寄件者: sun wo wong <[REDACTED]>
寄件日期: 2026年08月05日星期三 16:47
收件者: Adrian Tsz Hin TAM/PLAND; tpbpd/PLAND
主旨: A/NE-TKL/839
附件: 回應部門提問04-08-2026(1).pdf; 雨水排放建議書04-08-2026.pdf

回應部門擬問

PROJECT : Proposed Temporary Rural Workshop (Furniture Processing) with Ancillary Warehouse for a Period of 3 Years at Lots 2264 and 2265 (Part) in D.D. 76, Ta Kwu Ling, New Territories	DRAWING TITLE : F.S. Notes, Legend, Fire Service Installation Layout Plan		ARCHITECT :	CONSULTANT :	FIRE SERVICE CONTRACTOR : Century Fire Service Engineering Co., Ltd.		NAME	DATE	DRAWING NO : FS-01	REV. 0	
						DRAWN BY	C.K.NG	4 May 2024	SCALE : 1:500 @ A3		
						CHECKED BY			SOURCE : B.O.O. Ref. BD F.S.D. Ref. FP		
						APPROVED BY					
		REV				DESCRIPTION	DATE

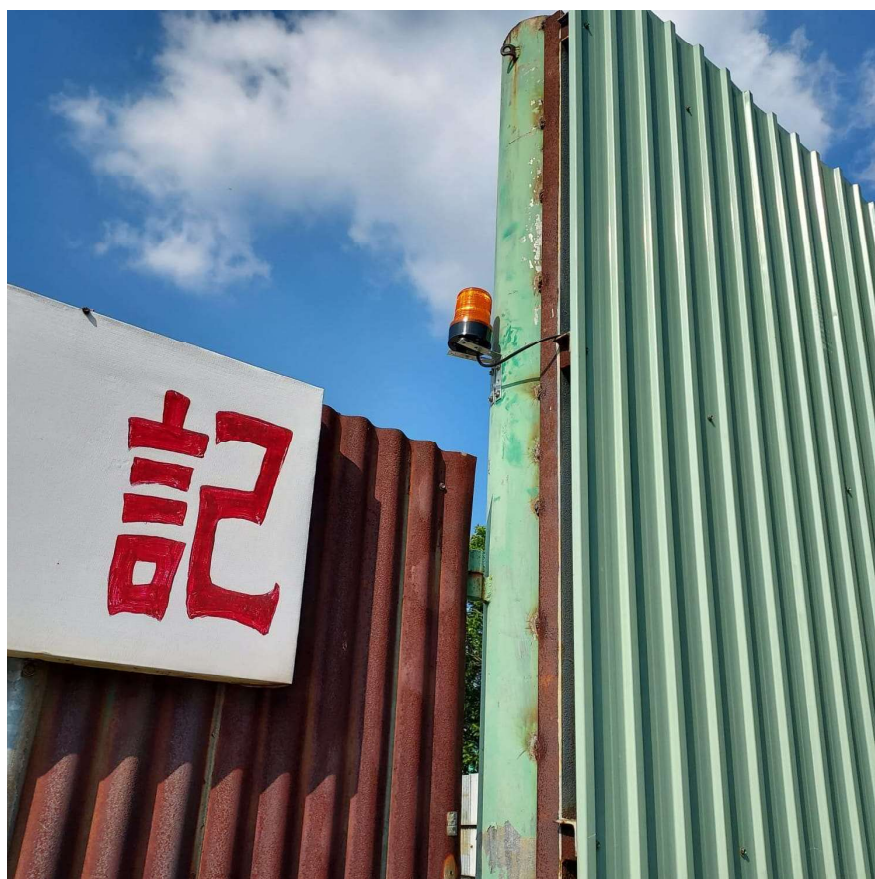
6 你在申請表格上指此規劃申請沒有涉及填土工程，然而地盤已經進行了填土工程有硬鋪面。申請人需要申請填土規範化，並且補充所使用的填土物料、相關填土高度、以及承諾不會再在地盤上進行任何填土工程。

回：我等在 A/NE-TKL/633 及 A/NE-TKL/715 都沒有申請填土地點，因此在是次申請沒有加上填土工程，我等會向貴會申請填土規範化 (隨函附上申請填土範圍圖)，有關填土物料為混凝土度厚度是 0.15 米，填土前的水平基準為+12.65mPD，現時的水平基準為+12.80mPD 是次申請如獲批准我等不用再進行任何填土工程。

車輛出入示意圖。

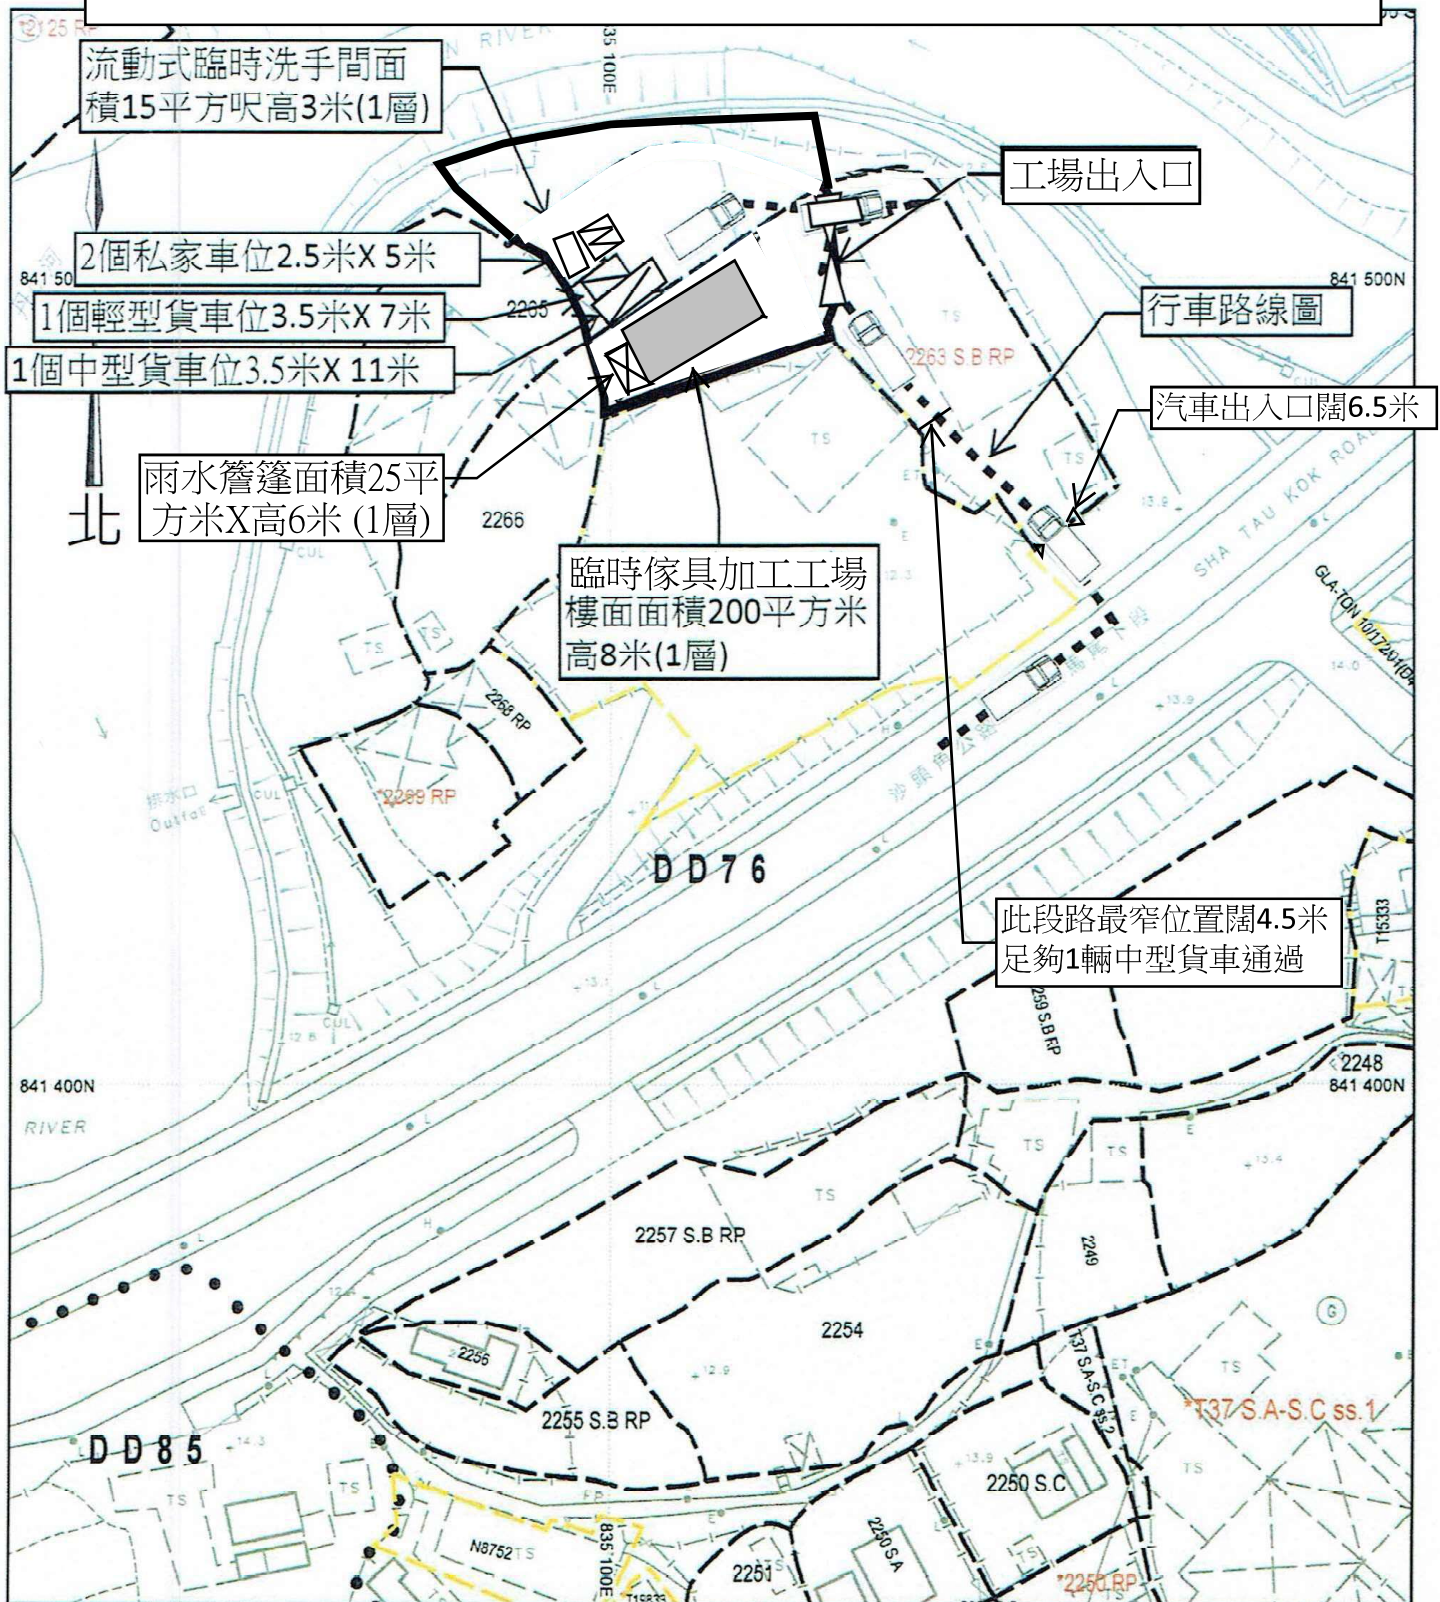
7 請補充通往地盤的車路走線。

場內所有車輛都係業權人所有而申請地點的車輛需要經過2263SB.RP的土地。亦為申請人所有。所以絕對不會令至沙頭角公路有車輛輪候進入場地的問題出現。

而我等亦會依照申請書上說明在門口的位置安裝旋轉警示燈及在行人路旁。安放行人過路指示牌通知所有司機小心出入。

雨水排放建議圖

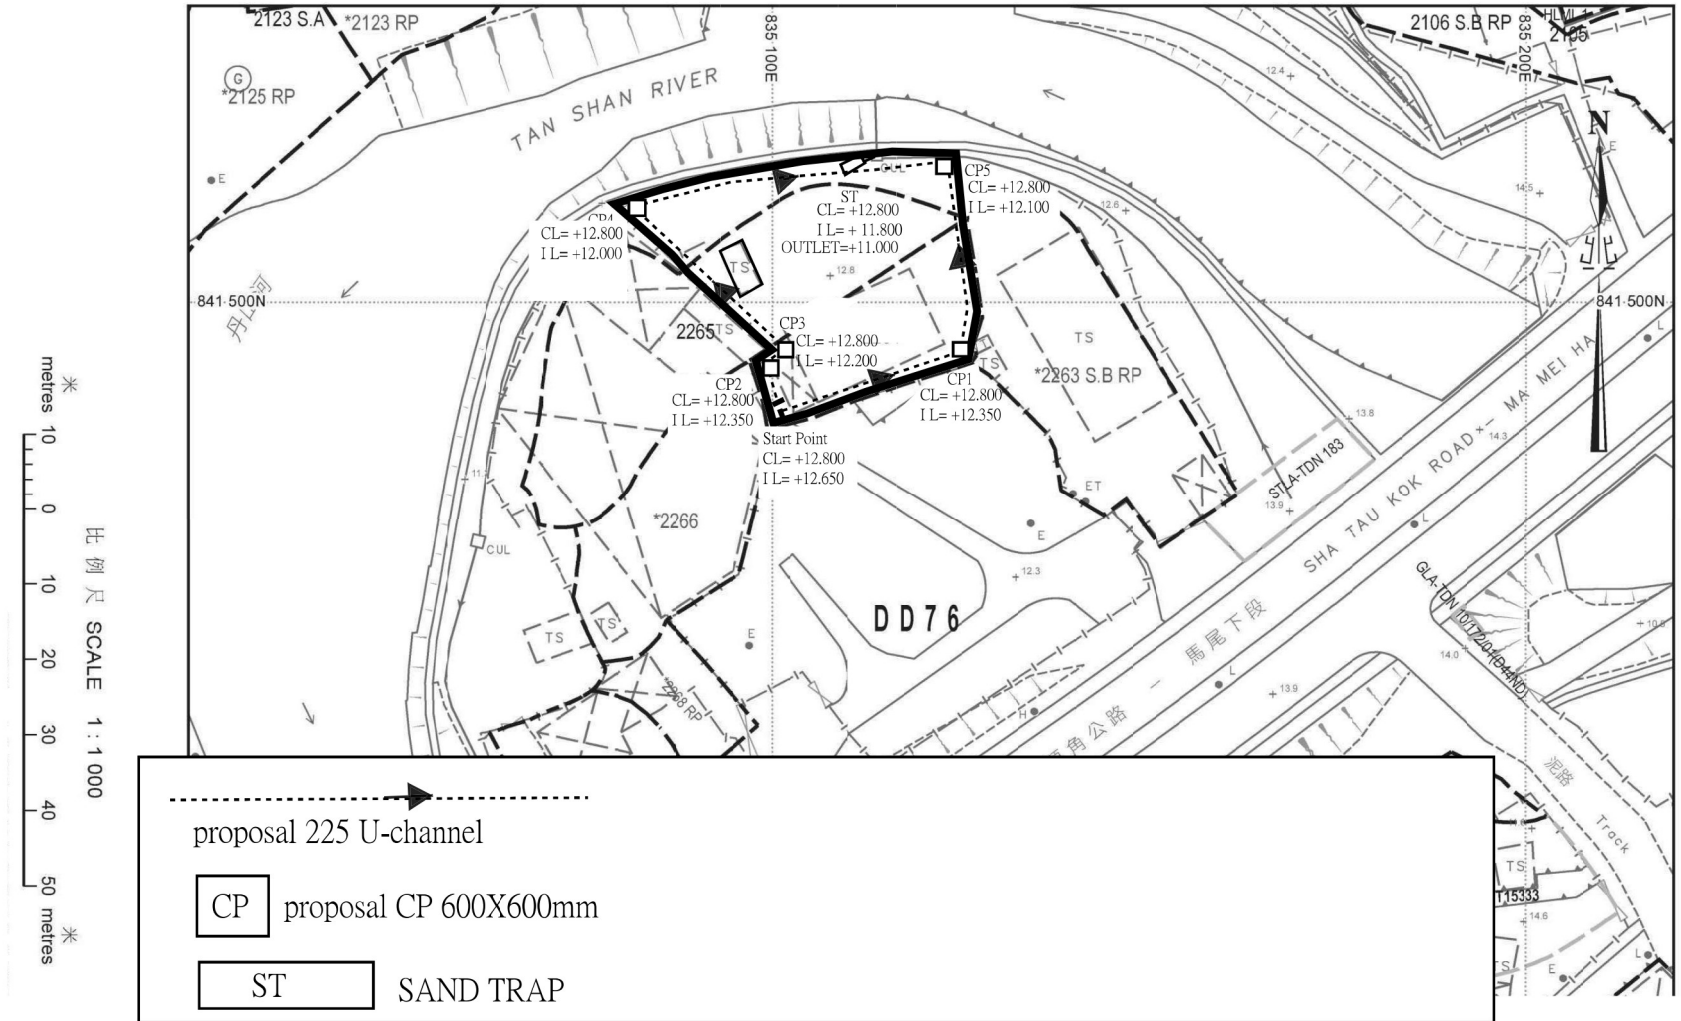
3 申請人已經履行了先前規劃申請編號 A/NE-TKL/715 的附帶條件(c)及(h)項，即設置排水設施及提交環境紓緩措施建議。可是由於申請人已經連續 2 次未能履行規劃申請的附帶條件而令到相關規劃許可遭撤回，申請人需要提交所有有關先前規劃申請編號 A/NE-TKL/715 的附帶條件的建議書，且在此規劃申請獲批前被相關政府部門接納。因此，你需要提交（1）排水建議書（已提交）；（2）交通管理措施建議；（3）消防設備建議書；及（4）先前規劃申請編號 A/NE-TKL/715 下環保署已接納的環境紓緩措施建議。另外，因你在申請表上表示已經完成了有關排水及消防設備的工程，請你亦提供有關的落實資料。

Site Catchment Area = $1120 \text{ m}^2 = 0.001120 \text{ km}^2$

Peak runoff in $\text{m}^3/\text{s} = 0.278 \times 0.95 \times 240 \text{ mm/hr} \times 0.001120 \text{ km}^2 = 0.07099 \text{ m}^3/\text{s}$
 = 4437 liter/min
